# Service-Information

Group 12 Motor-Electrics	September 1979	Bulletin No. 12 004 79(2003 )
-----------------------------	-------------------	----------------------------------

Subject: Battery -  
Starter Cable R 65

Illustration No. 1

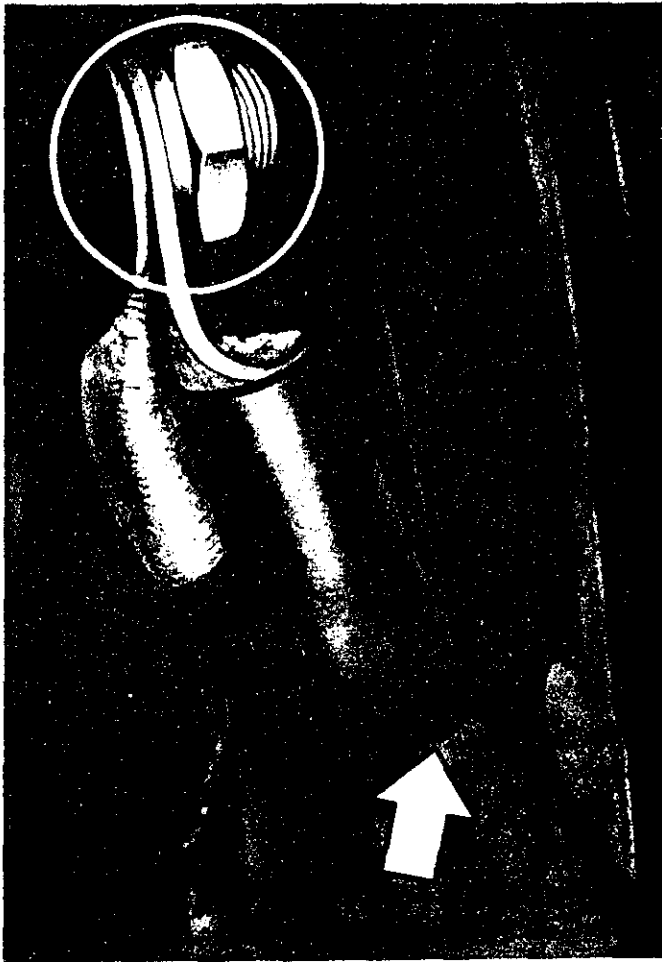
If the cables are installed as per Illustration No. 1, a possibly serious short could occur.

Possible short created by  
the wrong assembly of both  
cables. (See arrow.)

The correct assembly is shown in Illustration No. 2. In addition, after the nut is tightened, push down the end of the cables, away from the engine housing.

Correct assembly.
